**AGENDA FOR THE REGULAR MEETING OF THE
DESIGN REVIEW SUBCOMMITTEE**

Wednesday, June 11, 2014

To: Design Review Subcommittee
From: Sean Nicholas, Associate Planner *SN*
Subject: Pre-Application-Talega Village Center Master Sign Program
Amendment (second review)

SUBJECT: **Site Plan Permit 13-161/ Cultural Heritage Permit 13-162/ Conditional Use Permit 13-163, Cabrillo Mixed-Use,** a request to consider a new mixed-use development consisting of a two-story commercial building and a separate two-story residential structure with basement level parking. The project is located at 176 Avenida Cabrillo within the Mixed-Use zoning district (MU3-p-A-CZ).

A NEW SINGLE FACED ILLUMINATED DIRECTIONAL SIGN

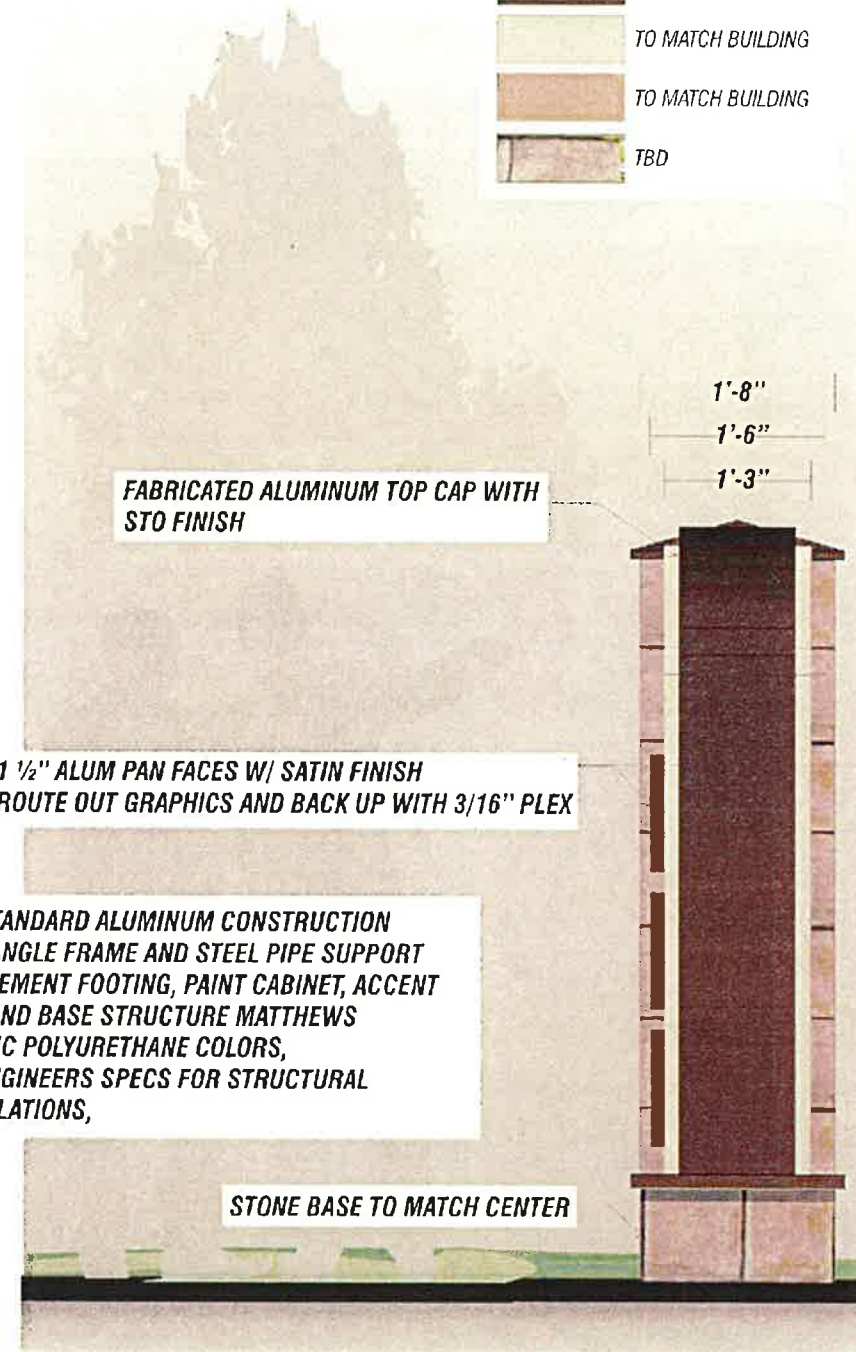
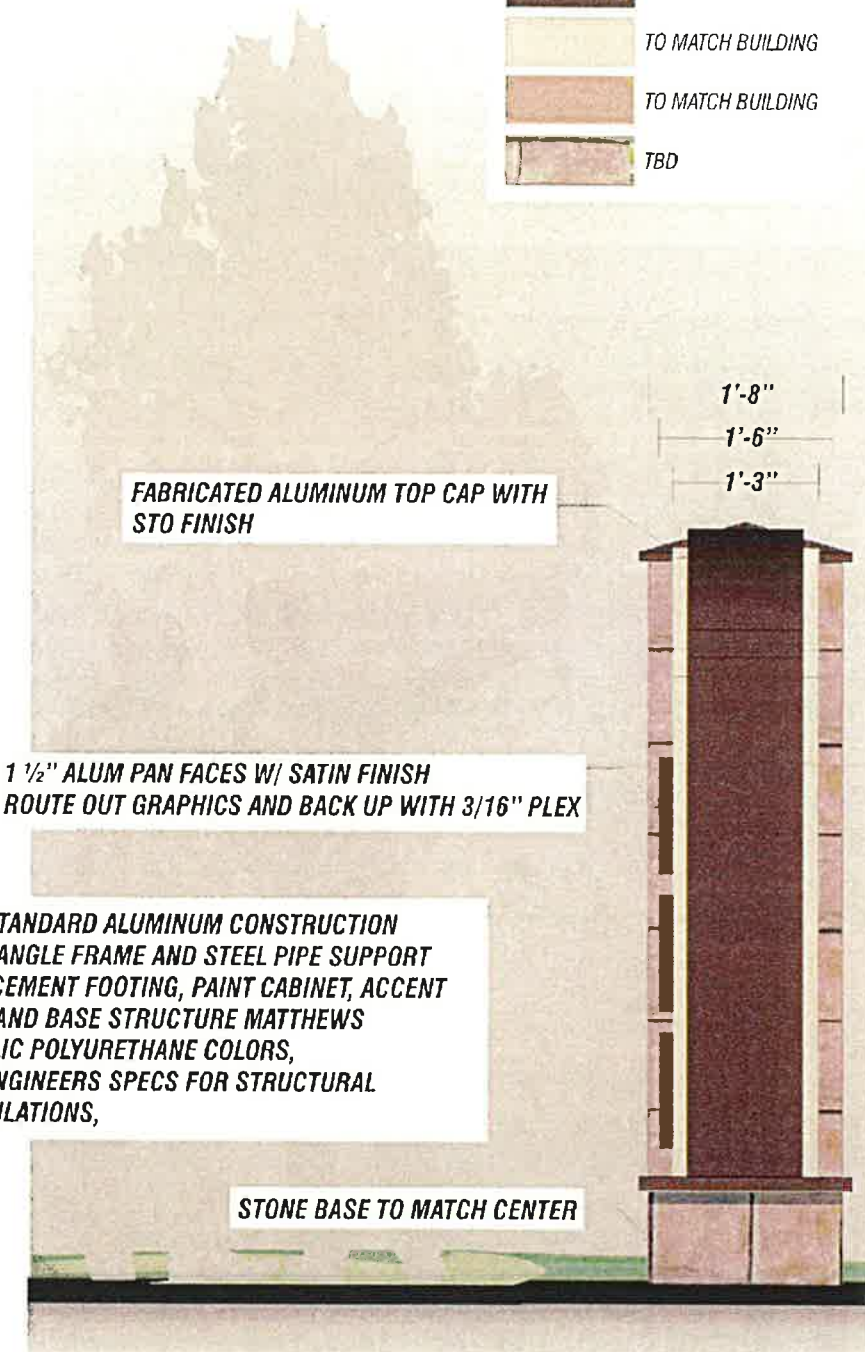
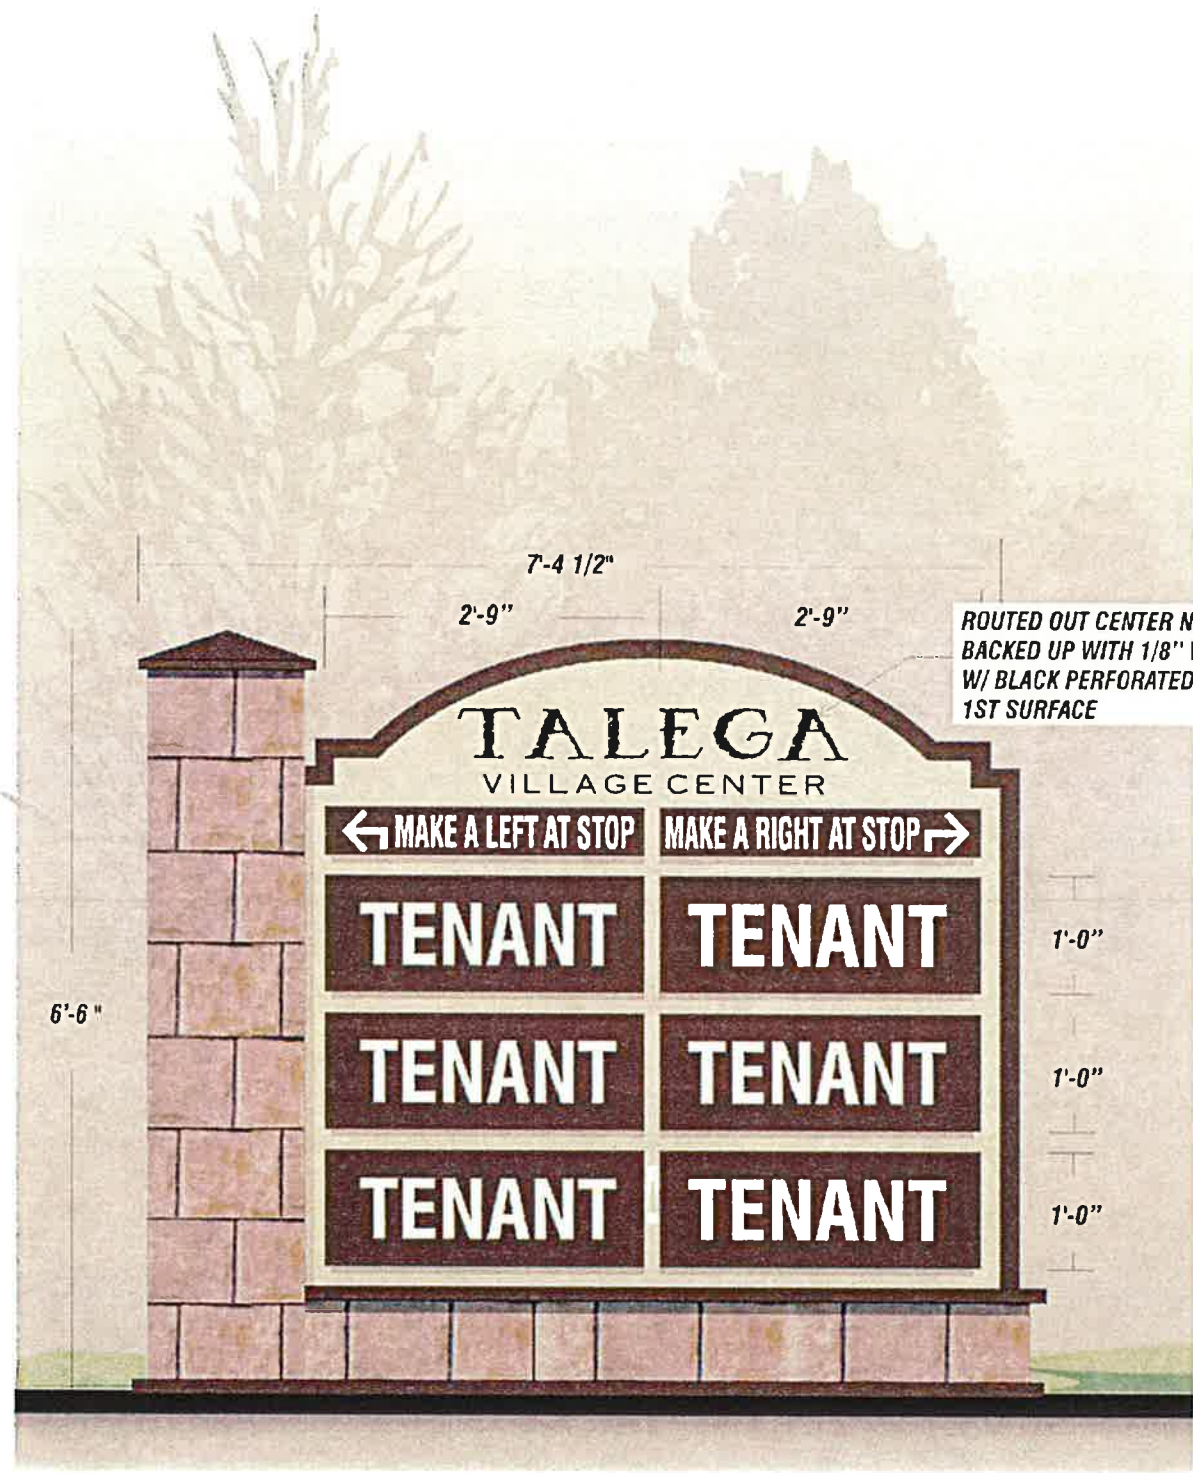
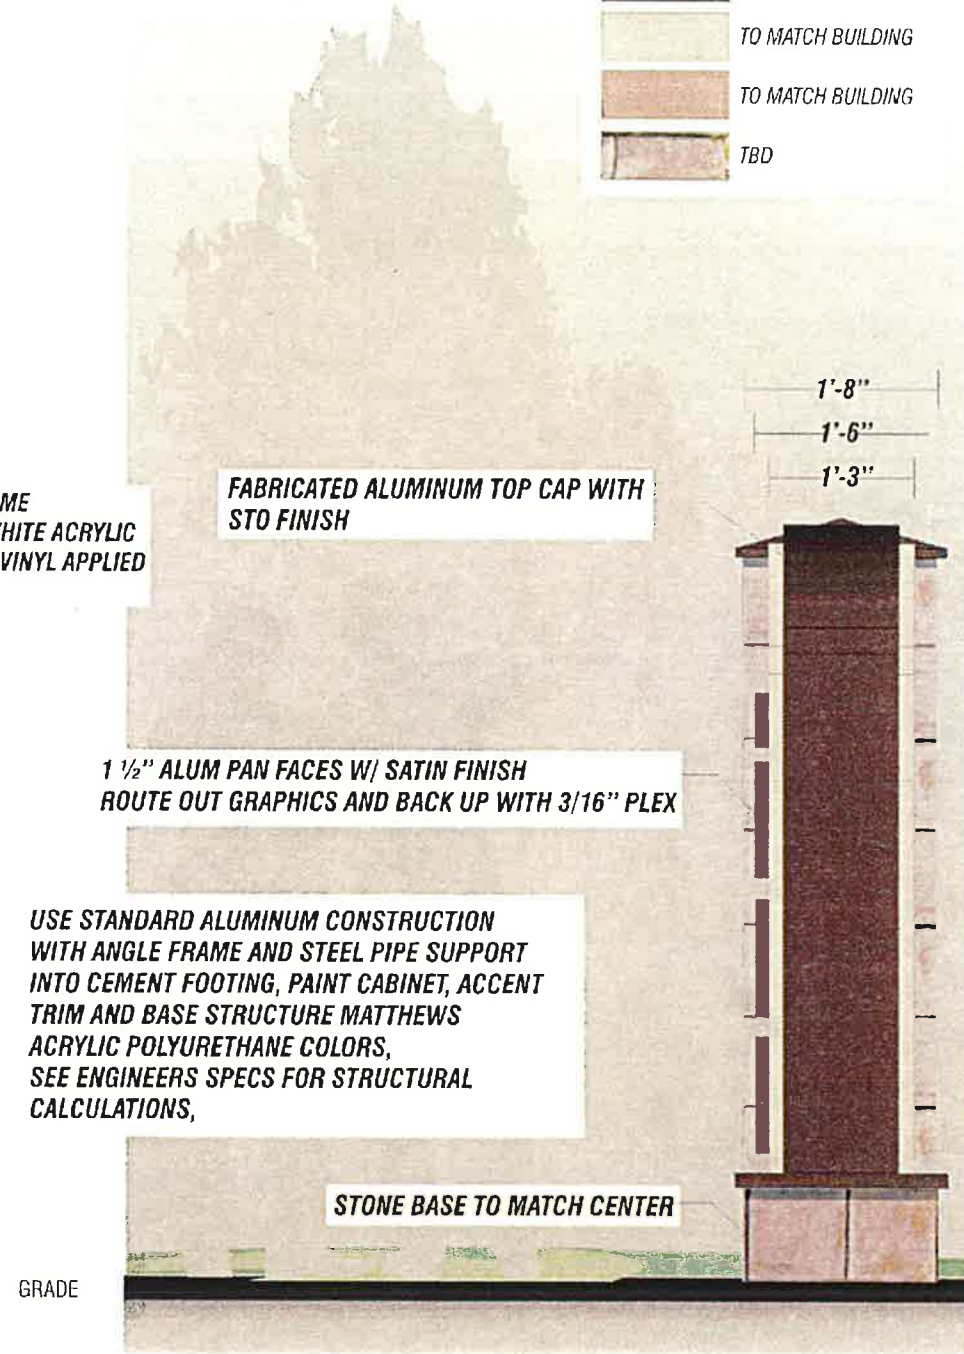
- 2) *Monument sign design*-Staff still has concerns about the overall designs of the monument signs. While the applicant has addressed some concerns, especially related to arrow clutter and the incorporation of more stone elements. After reviewing the proposed modifications, staff recommends utilizing signage similar to that shown above. Staff had previously provided these images to the applicant as an alternative simplified design of the monument signs and are consistent with approved Talega signs. Staff is still concerned about the fabrication/construction materials of the primary body of the sign being aluminum construction.

- 2) *Monument sign design*-The overall designs of the monument signs need to be reconsidered to remove the fabricated aluminum cap. Monument signs, characteristic of the main monument signs for the center, would be a better design option. This may be accomplished by increasing the amount of stone utilized, or by re-evaluation the fabrication/construction materials of the primary body of the signs. There is staff concern that the proposed monument signs would not be consistent with the high quality stone entry monuments, and would negatively impact the development.

Subcommittee Member Crandell stated that he had concerns that the monument signs looked to crowded. He suggested removing some of the arrows and other features. He also stated that the signage should be more structurally contained within the signage. Subcommittee Member Crandell stated that right now the signs seem to be just planted onto the monument signs with no real thought of consistency or integration.

D1 NEW REVERSE PAN HALO LIT LETTERS
SCALE: 3/4" = 1'-0"

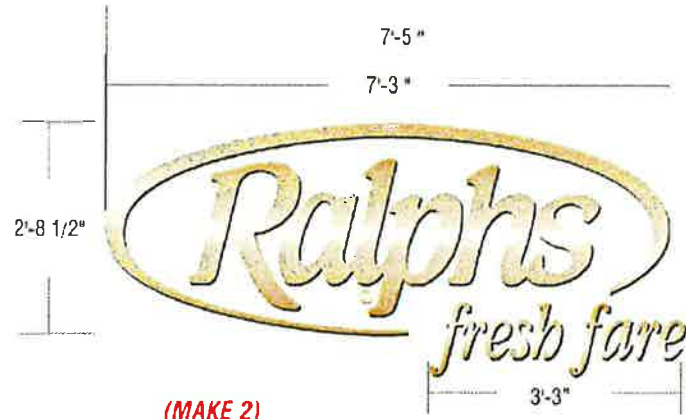
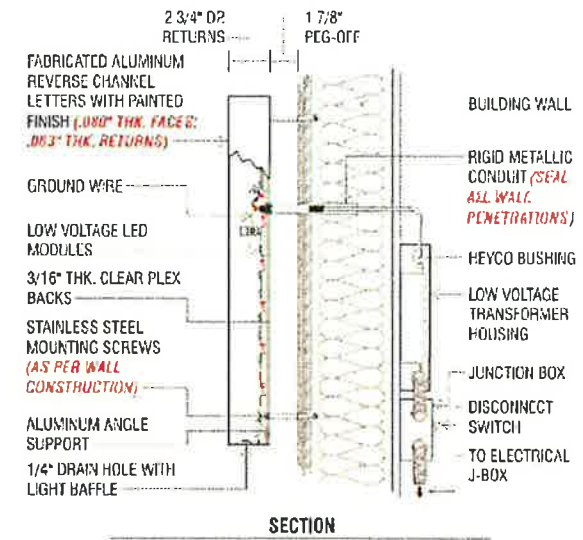
- 3) *Materials and lighting*- Staff does not support increasing the size of the individual signs on the entry monuments. Additionally, due to the printed color of the plans provided by the applicant, staff has concerns about the proposed color not being appropriate. Before a recommendation on the color can be determined, the applicant will need to provide a color and materials sample to be reviewed in the field. Staff supports the use of pin mounted metal lettering and the halo illumination for the Ralphs sign and the other potential tenant.

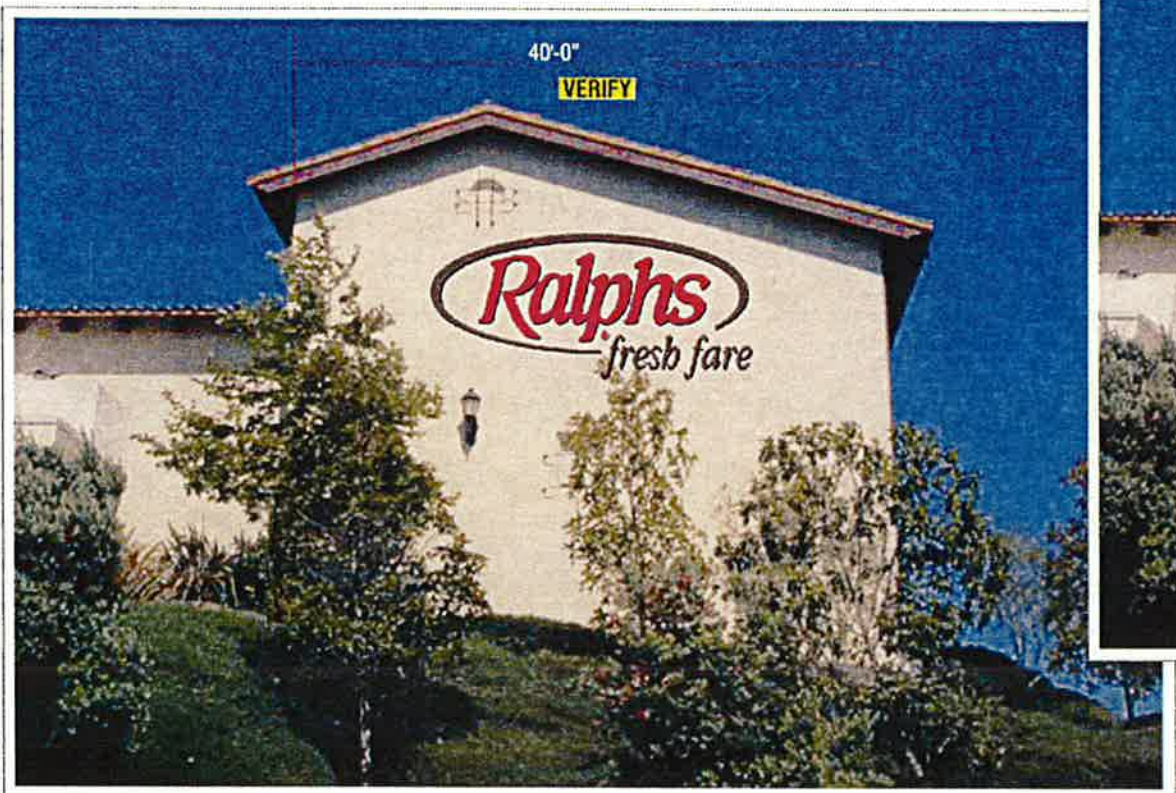
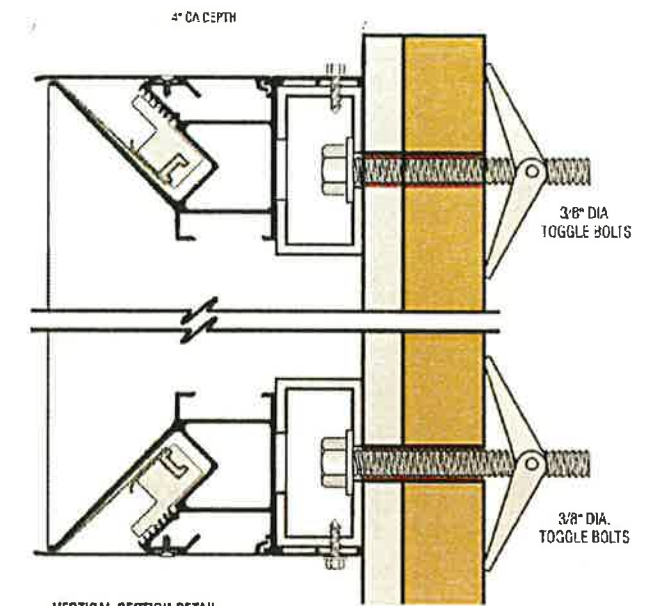
Staff has reviewed the revised internally illuminated acrylic sign, and still does not support the sign because: 1) All signs on the building should match in design, materials, lighting, and scale; and 2) the sign is much larger than the 64 square feet allowed by sign regulations. The applicant brought up Target, and based on the size and scale of that building, staff did recommend support of a 10 'x 10' sign as long as it was pin mounted metal with halo illumination. Staff recommended if the sign was plastic and internally illuminated that it should only be allowed to be 8' x 8', thus staff did not support a Sign Exception Permit. Staff's position is all signage

- 7) *Materials and lighting*-No vinyl or other internally illuminated signage should be used. Staff recommends modifying the Ralphs sign in the following ways: 1) maintain the individual metal pin-mounted letters in the bronze finish; and 2) re-install the sign to allow for halo-illumination. No modifications should be done to the existing Talega Village Center sign, other than an alternative up-lighting option in the landscaping. Staff believes that there may be potential for an additional tenant sign on the opposite side of the monument sign to mirror the Ralphs sign in material, illumination, and size. Staff does not support increasing the size of the individual signs on the entry monuments.
